DC POWER SUPPLY
HVR SERIES, MODEL 6522A
SERIAL NUMBER PREFIX 5J

MANUAL CHANGES

Model 6522A DC Power Supply
Manual HP Part No. 06522-90001

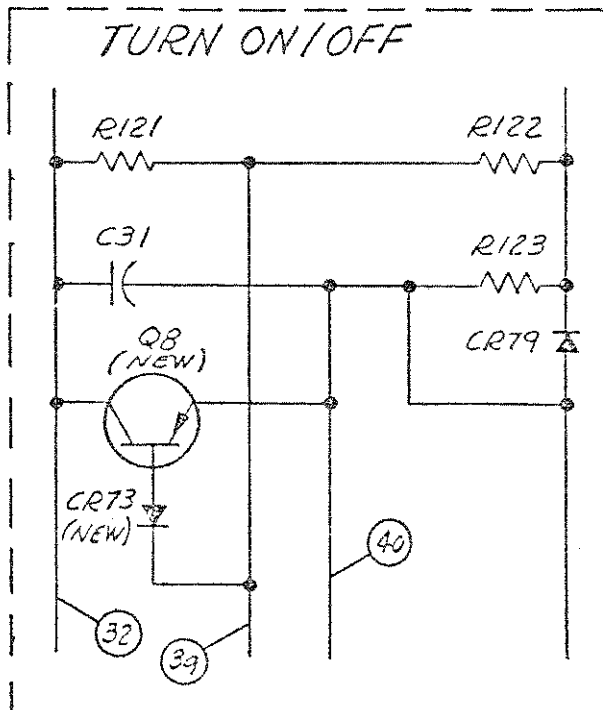
- C29: Change to 200 μ F, 65V, HP Part No. 0180-1884.
- Q8: Add A8, Si, PNP, HP Part No. 1853-0099.
- CR73: Add CR73, Si, Rect. HP Part No. 1901-0033.

On the schematic diagram, add new transistor and diode as shown in the following sketch. Q8 prevents F3 from blowing when unit is turned on and off rapidly.

Figure 3-2. Paralleling Two Supplies

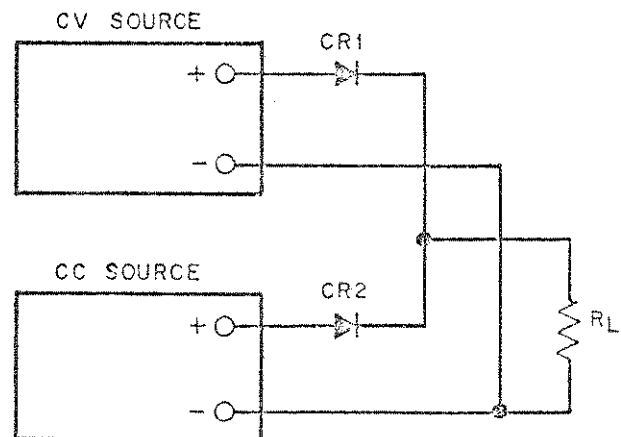
Change paragraph 3-13 (parallel operation) to read as follows: Two power supplies can be connected in parallel to obtain a combined output current greater than that available from one supply. The total output current is the sum of the output currents from each individual supply. Since the inputs to the supplies' error amplifiers are not available, the two supplies must be connected in straight parallel with one supply operating as a constant voltage (CV) source and the other supply operating as a constant current (CC) source. To protect the supplies' input voltage amplifiers, diodes CR1 and CR2 are added between the + output terminals and the load as shown in Figure 3-2. If the diodes are not added, damage may occur when one supply is turned off with the voltage controls set for zero volts or to some low value.

- a. With both supplies turned off, connect the load and the protection diodes as shown in Figure 3-2.
- b. Turn on the CC supply (leaving the CV supply off), set the CC supply's voltage controls for maximum and adjust its current control for one-half the desired output current.
- c. Turn on the CV supply and with its current control set to maximum, adjust the CV supply's voltage controls for the desired output voltage.

The CV supply's output voltage will be slightly higher than the voltage across the load by an amount equal to the drop across diode CR1 plus the drop in the load connecting wires.

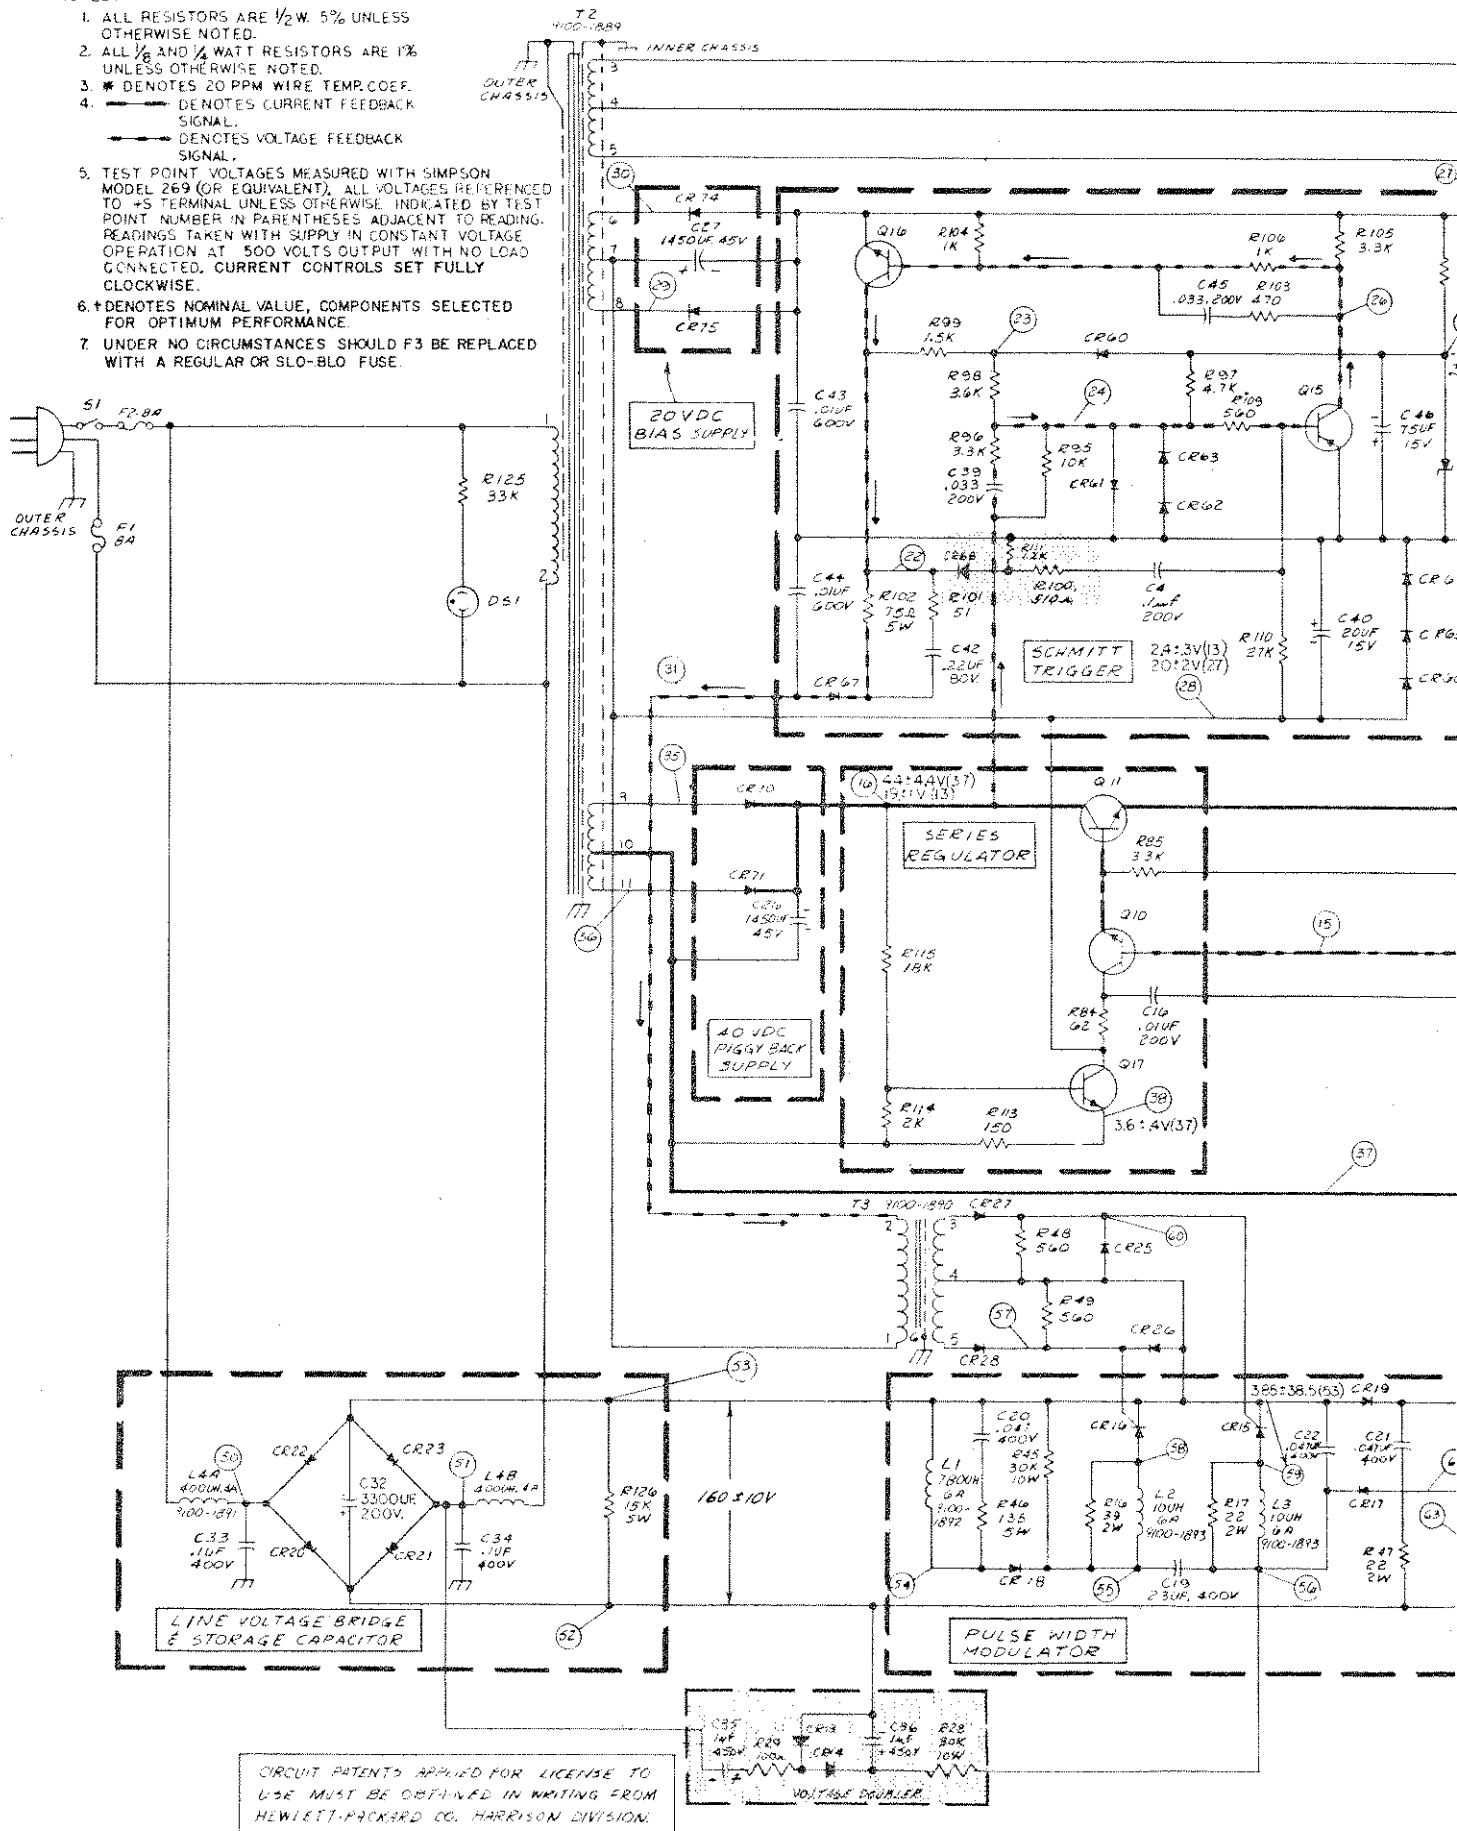
All of Change 4 is shown on the schematic on the separate

page. For convenience, this schematic may be pasted down on top of the existing schematic at the rear of the manual.

Note that all applicable changes listed under ERRATA have also been made on this paste-down schematic.

Figure 5-4. Constant-Current Test Setup Diagram

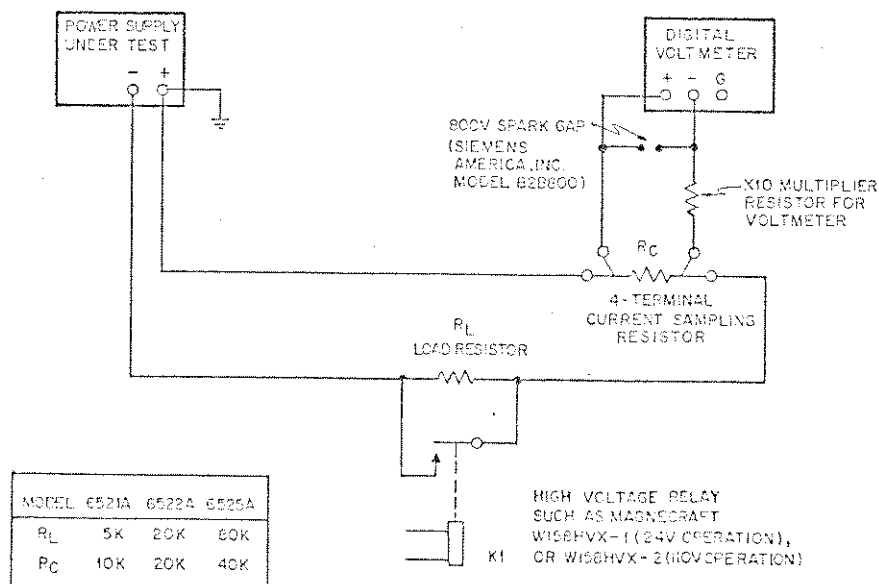
To improve personnel safety and reduce the risk of test equipment damage, the Figure 5-4 test setup for the constant-current tests of par. 5-18 through 5-25 has been changed as shown below. Shorting switch S1 has been replaced by a high-voltage relay, R_L has been moved to the negative output line, and a high stability X10 multiplier resistor and a spark gap have been added to protect the voltmeter. The positive output of the power supply must be grounded to the chassis as shown.
